ALAMO RANCH

1,693.0 ACRE TRACT
MASTER DEVELOPMENT PLAN

MDP # 808D

Re: Alamo Ranch **MDP # 808-D**

JOB NO. 5629-68
DATE FEBRAUARY 2006
DESIGNER CBD
CHECKED SLW DRAWN CBD
SHEET C1.00

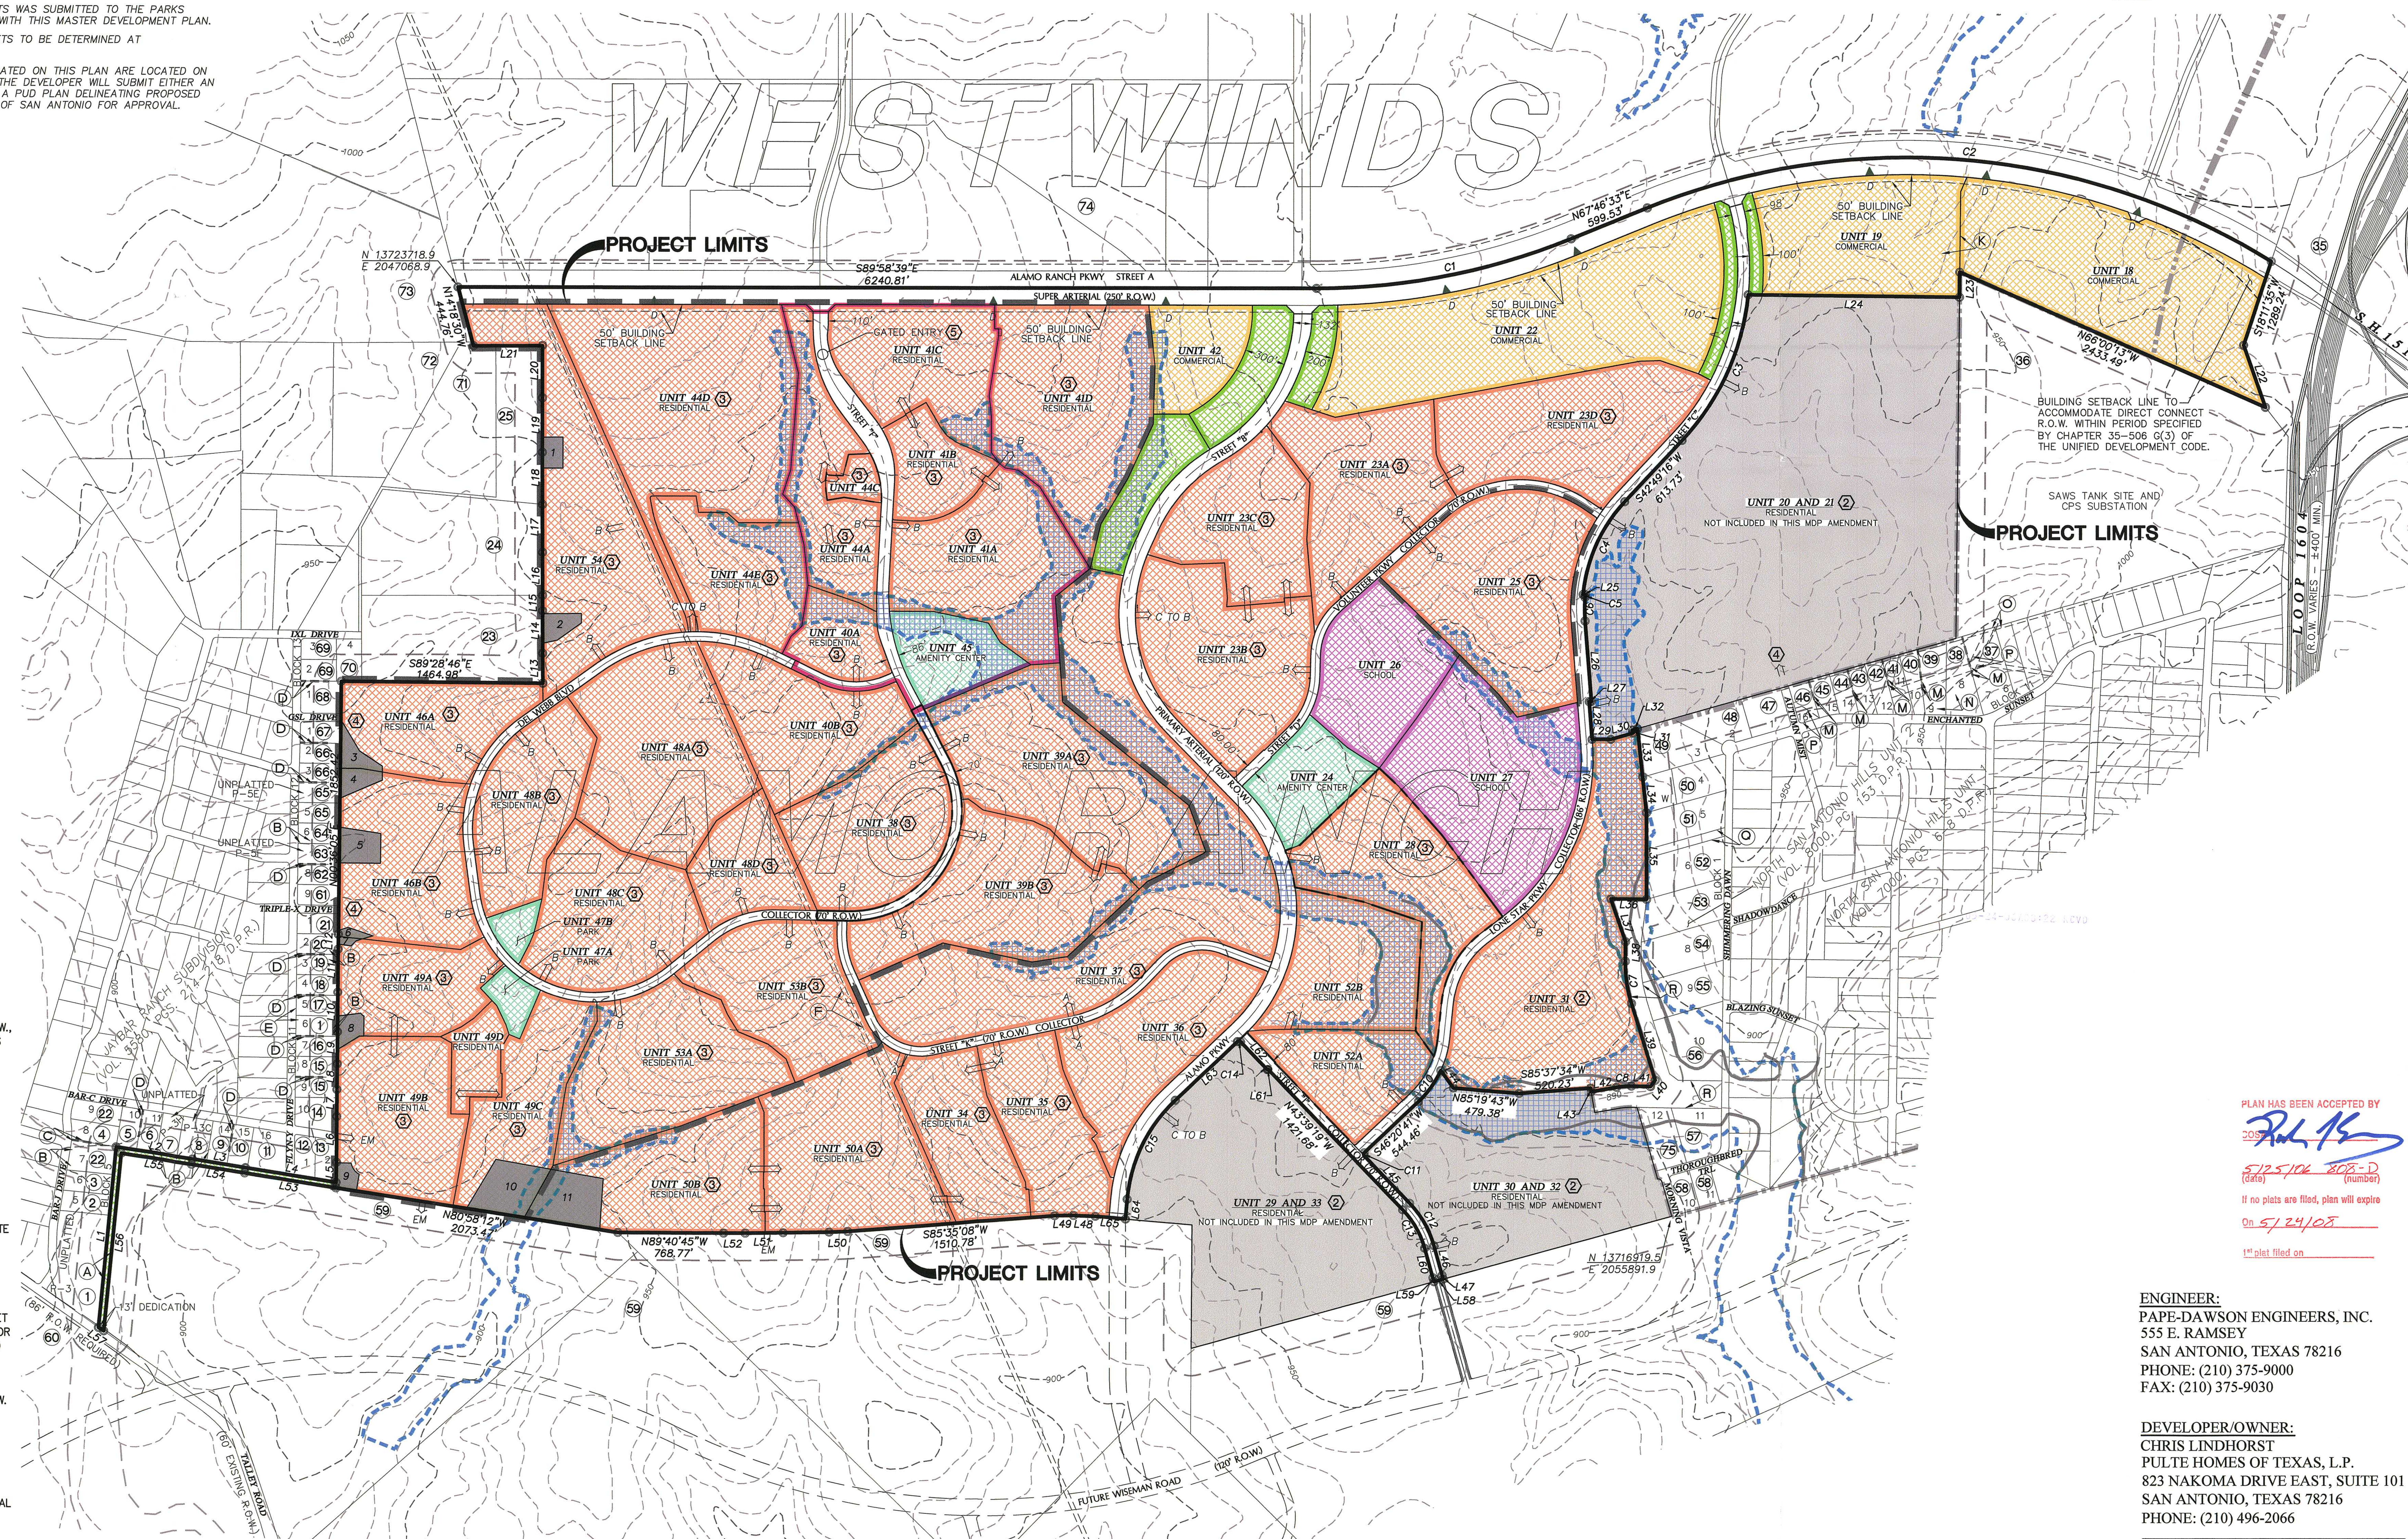
- In consideration of public safety and convenience, excessive grades by reason of topography should be avoided in street layouts and arrangements.

- Any access and R.O.W. issues along state facilities will need to be resolved with the **Texas Department of Transportation (TXDOT).** For information about these requirements you can contact TXDOT at 615-5814.

- **DSD – Traffic Impact Analysis & Streets** indicates that the following requirements and onsite improvements are necessary and shall be provided by the developer, on and before the completion of the Westwinds MDP, at no cost to the City of San Antonio:

- All access roadways and driveways shall provide clear sight distance on all existing and proposed roadways in order to provide adequate obstruction free viewing distances for approaching traffic. All signage, landacaping and improvements shall be selected and located so as not to block these clear sight distance areas.

- The developer shall be responsible for probiding sidewalks along all internal and adjacent external roadways where non-existing or not in compliance with ADA (Uniform Development Code (UDC) – 35-506(q)

- All streets and driveways shall follow UDC 35-506 including 35-506, (r) Access and Driveways.

- **No internal streets network has been provided. The Streets Division review is in no way a review of an internal street network. Streets reserve the right to make further comments should a detailed internal street network be provided. UDC 35-506 will be implemented at the time of platting.**

- **Trees** approves with the following conditions:
  - 2003 Tree Preservation ordinance standards per UDC 35-523 – a Master Tree Permit has been approved for this development – A/P 1052162.

- Streetscape standards apply as per UDC Section 35-512 (we recommend preservation of existing trees where available and possible)
- **Parks** approves with the following conditions:

- Area #1 consists of Units 20/21, 30/32, 31, 29/33 and 52(A-B). This section will pay a fee-in-lieu of parkland dedication or provide a parks plan which meets requirements for each unit at the time of platting.

- Area #2 consists of Units 23(A-D), 25, 28, 34, 35, 36, 37 and 50(A-B). The requirement for this section is **9.8** acres. This section has privided **10.9** acres of park as Unit 24.

- Area #3 consists of Units 38, 39(A-B), 40(A-B), 41(A-D), 44(A, C-E), 46(A-B), 48(A-D), 49(A-D), 53(A-B) and 54. The requirement for this section is **18.7** acres. This section has provided 10.2 acres of park as Unit 45, plus 2.7 acres of park as Unit 47A, plus 2.3 acres of park as Unit 47B for a **total** of **15.2** acres. The remaining **3.5** acres of parkland dedication are to be gained by providing park amenities. The parks plan of said amenities must be provided at the time of platting. As stated in UDC section 35-503(f); subdivisions proposed in phases shall provided parkland in increments equal to the acreage required.

- The parkland provided is dedicated to the Home Owners Association.
  - A Provision and Maintenance Plan is provided to this department at the time of platting.

- Parkland dedication, for each separate area, must be platted by the second phase of development. A detail of the amenities needed for credit must be provided with the plat. No further subdivision plat shall be approved unless and until parkland is provided in increments equal to the acreage required.

- All amenities provided for credit meet standards set forth in the Unified Development Code.
  - Any phases which become multi-family must provide supplemental information at the time of platting in order to determine park dedication requirements.

- All plats associated with this development which were filed prior to this approval must meet these standards and conditions.
- **Bexar County** states the following improvements will be provided by the developer prior to completion of the Alamo Ranch Subdivision:

- Alamo Ranch Parkway (SH 151 extension) is not designated as a state highway west of Loop 1604, however it will be extended west of Loop 1604 as a four lane divided Super Arterial with a minimum of 250 feet right-of-way

- Alamo Parkway is classified as a primary arterial with 1520 feet right-of-way, and will be extended through this dvelopment as a four lane divided roadway

- Street "F" will be a loop road within the senior adult community, and will be constructed as a four lane divided roadway with turn lanes provided at all internal intersections.

- The primary gated entry of Street "F" shall provide for adequate queue storage and turn around capcity for the full build out of the senior adult community. If queuing at the main enterance interferes with the public right roadway system, then Bexar County reserves the right to require appropriate action to eradicate the problem

- Roadyway configurations adjacent to and within the Alamo Ranch Subdivision shall be consistent with Table 14 of the Seale Ranch Level Three Traffic Impact Analysis prepared September 2004. Residential lots shall not side against any roadway classified a thoroughfare or greater.

- Traffic controls shall be warranted as per the Texas Manual on Unified Control Devices and approved by TxDOT and / or Bexar County.

- It will be expected that you will plat all of the property depicted in your Master Development Plan (M.D.P.) to include floodplains, drainage areas and open space.
